SANITARY SEWER IMPROVEMENTS TO SERVE
BRUSH CREEK 3RD ADDITION
PHASE 2 - LOTS 3 - 8

Private Project Number **916 PPS (607861)**

PROJECT INSPECTED + ASBUILT
 BY BAUGHMAN COMPANY 1/00

SANITARY SEWER TO SERVE
Brush Creek 3rd Addition
LOTS 3-8

SHEET
3
6

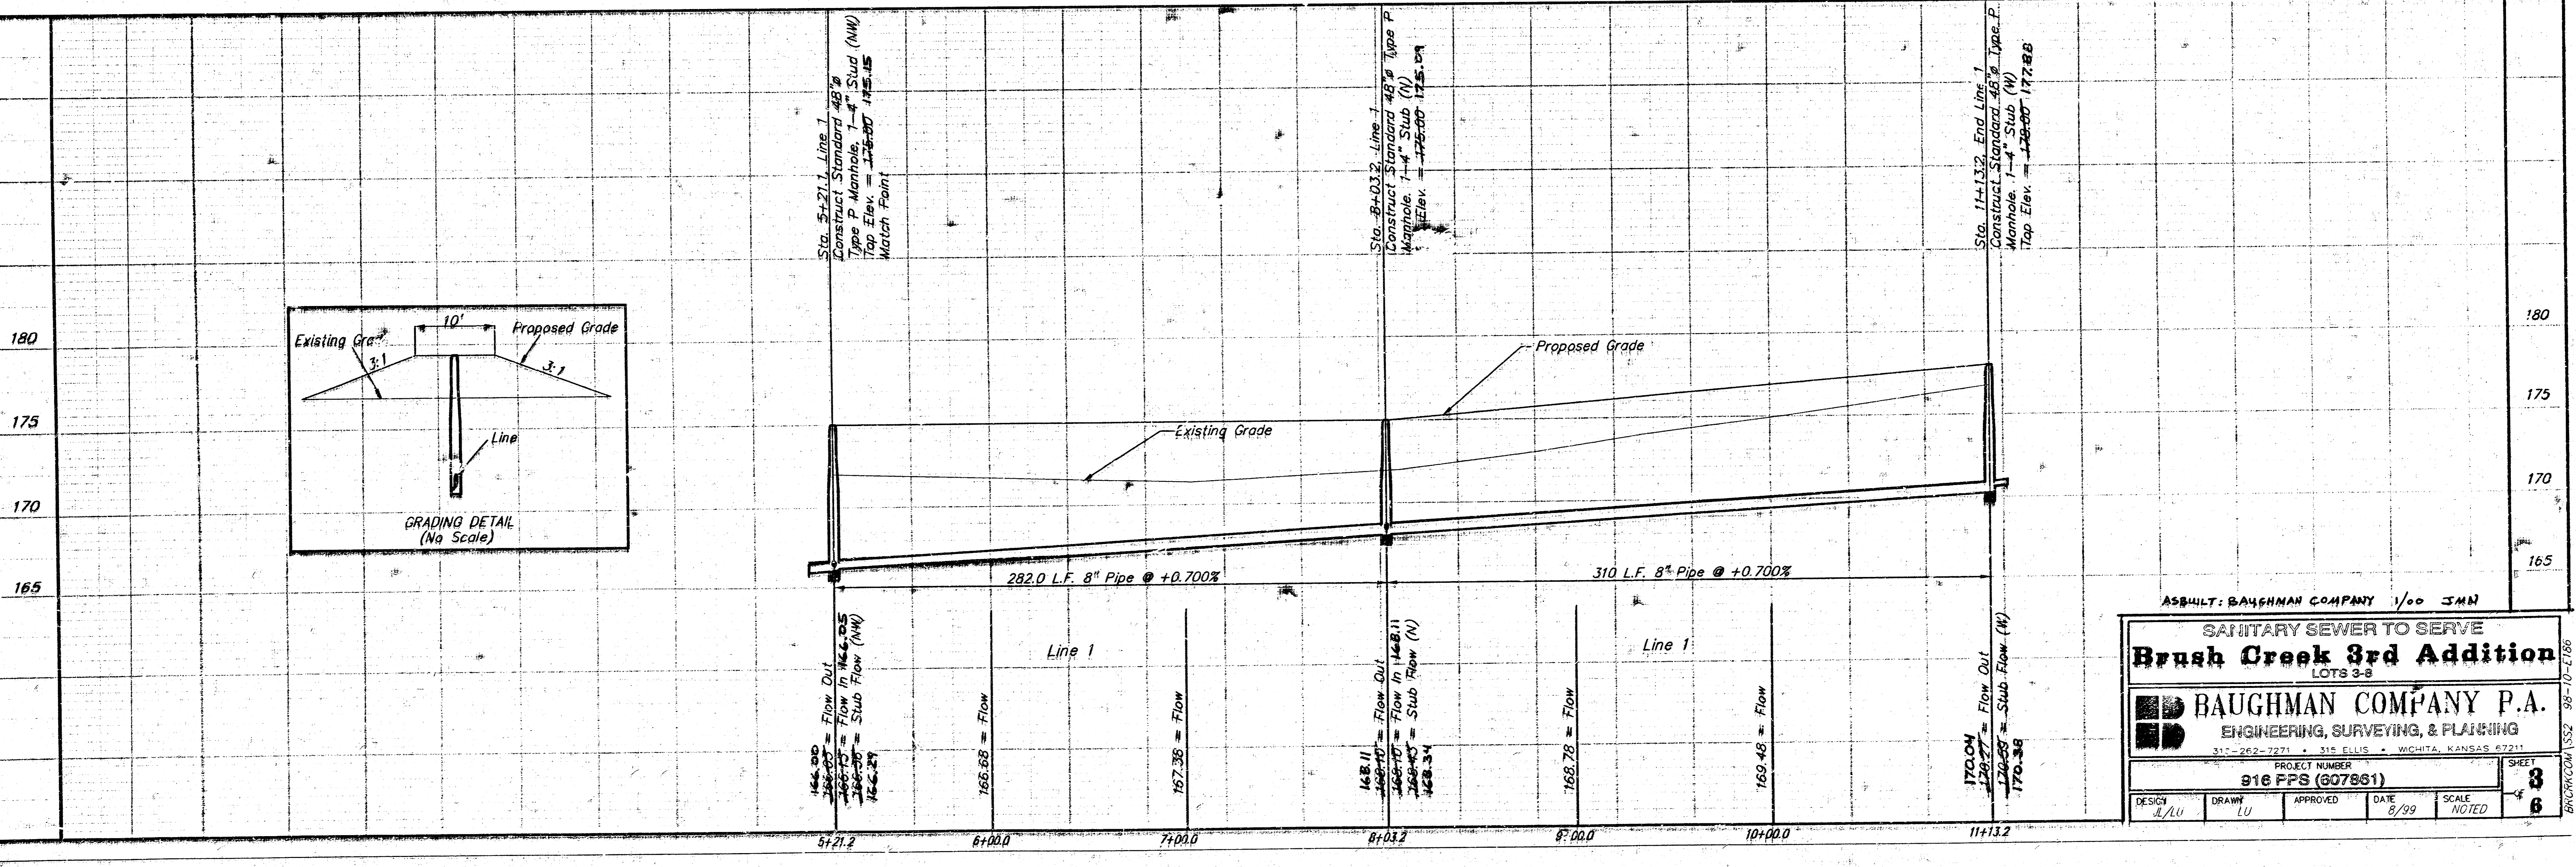
Sta. 5+21.1, Line 1
Construct Standard 48" Type P Manhole, 1-4" Stub (NW)
Top Elev. = 175.00 175.15
Match Point

Sta. 8+03.2, Line 1
Construct Standard 48" Type P Manhole, 1-4" Stub (N)
Top Elev. = 175.00 175.09

Sta. 11+13.2, End Line 1
Construct Standard 48" Type P Manhole, 1-4" Stub, W, SW
Top Elev. = 172.00 172.88
Delete Stub (sw)
